# Technical Bulletin

## FMM-7045 Manual Pull Stations

- ▶ Bosch / FMM-7045 pull stations

**January 19<sup>th</sup>, 2021**

Location of date code on inside cover of product

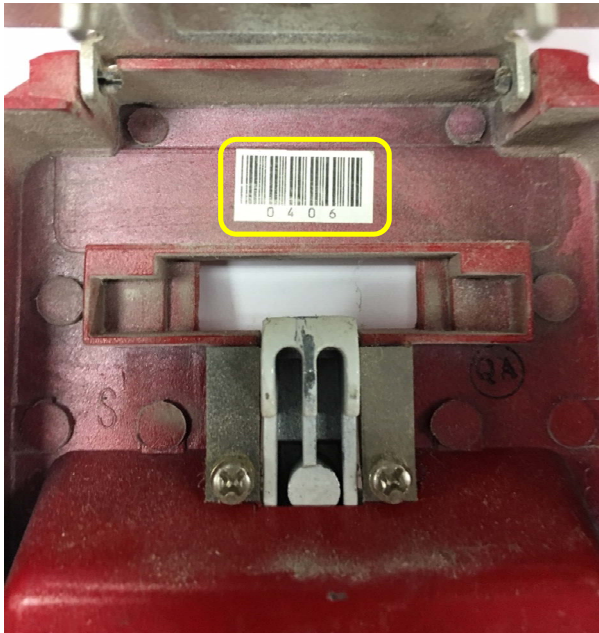
Bosch is issuing an advisory notice that a limited number of model FMM-7045 manual pull stations manufactured in 2006 and distributed around that time may be showing signs of intergranular corrosion due to a deviation from specifications.

Intergranular corrosion develops over time (typically over periods greater than 2 years) and may be identified as small fractures or cracks in the plunger assembly that activates the switch. Intergranular corrosion could affect the normal operation of the manual pull station. While we believe the risk that the pull stations will not operate is low, it is important to inspect the pull stations to ensure their operating condition.

You have received this bulletin because our records indicate that you may have purchased at least one of these products from Bosch during the affected time period. The product model number is located on the label on the inside of the front cover. Products in the affected date range are marked with date codes 06XX on the inside surface of the front cover. For date code locations, see the figures on the back of this sheet.

Please ensure that you inspect these units during your required NFPA 72 semi-annual visual inspections and annual functional testing.

Pull stations with signs of potential intergranular corrosion should be replaced and returned to Bosch.
